REVISED RESPONSE TO REQUEST FOR ADDITIONAL INFORMATION

APR1400 Design Certification

Docket No. 52-046

RAI No.:255-8285SRP Section:03.08.05 - FoundationsApplication Section:03.08.05Date of RAI Issue:10/19/2015

Figure 1 Typical Detail for Installation of Waterproofing Membrane

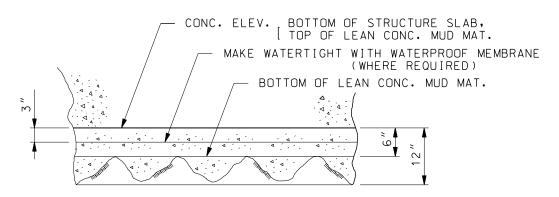
Applicant is requested to descript, whether waterproofing membranes are used in APR1400 design, and if used, provide effects on the shear resistance of the NI common basemat.

Waterproofing membranes are used for exterior horizontal and vertical surfaces of structures in APR1400 design. The incorrect sentence in "e" of DCD Tier 2, Section 3.4.1.2 will be deleted.

A typical detail for installation of the waterproofing membranes is shown in Figure 1. Because the membranes are installed between lower and upper lean concrete beneath the basemat, they affect the shear resistance of the NI common basemat.

The sliding by shear transfer may be considered across the interfaces between dissimilar materials, i.e., foundation concrete on lean concrete, lean concrete and waterproofing membrane, lean concrete and the supporting medium (soil or rock), and within the supporting medium.

The coefficient of friction between the lean concrete and waterproofing membrane is bounded by 0.55 as described in COL 3.8(13). This value is compared with the coefficients of friction between other interfaces, and the minimum value among them is used for stability check of the basemat.

Figure 1 Factor of Safety against Sliding at Each Time Step

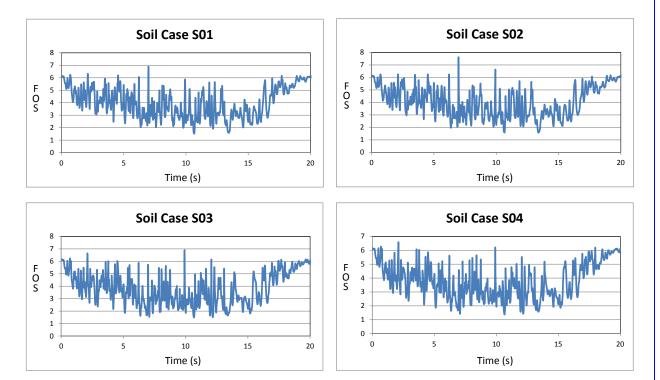
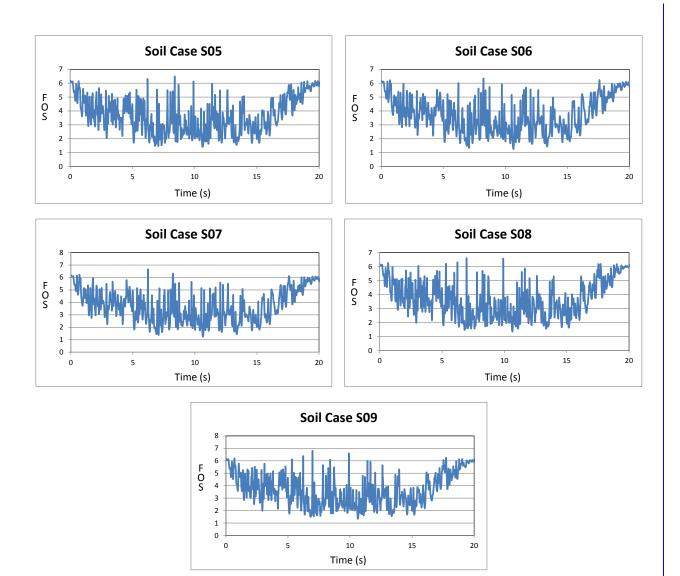
Technical Report (TR) APR1400-E-S-NR-14006-P, Rev. 1, "Stability Check for NI Common Basemat," Section 4.2.2, "Sliding Check," states that, "The resistance forces against sliding of the common basemat are checked for the driving shear forces generated for the seismic load. The basemat friction force is considered to resist the sliding of the common basemat." The applicant further stated that coefficient of friction for sliding check is 0.7. The applicant's approach for evaluating the sliding analyses of the Category I structures is not clear to the staff. SRP 3.8.5 II.4.G and B provides the criteria for determining the sliding forces and overturning moment of the Category I structures subject to seismic loads. Per 10 CFR 50.55a; Appendix A to 10 CFR Part 50, General Design Criteria 1, 2, 4, 16 and 50; and SRP 3.8.5, the applicant is requested to provide a detail description of the method used to determine the sliding check of the Category I structures; and to justify that the coefficient of friction of 0.7 represents the minimum coefficient of friction considering the various sliding interfaces including concrete to soil, waterproofing to soil, and concrete basemat to concrete mudmat.

The factor of safety (FOS) against sliding is calculated at each time step (t = $0 \sim 20.48$ seconds with an interval of 0.005 seconds) for each soil case (S01 ~ S09; S10 is a fixed base case), i.e., by linear time history method. The final result is shown in Table 1 and Figure 1 below.

The FOS against sliding is calculated by the ratio of resisting force to driving force. The driving force is calculated from seismic horizontal force of the NI structure. From the time history analysis result, the total sum of seismic horizontal force of the NI structure is obtained for E-W and N-S direction, respectively. At each time step, resultant horizontal driving force is calculated from the E-W and N-S direction forces by square root of sum of their squares.

Finally, the minimum FOS against sliding during the entire time period and for all soil cases is obtained as 1.25, as shown in Table 1.
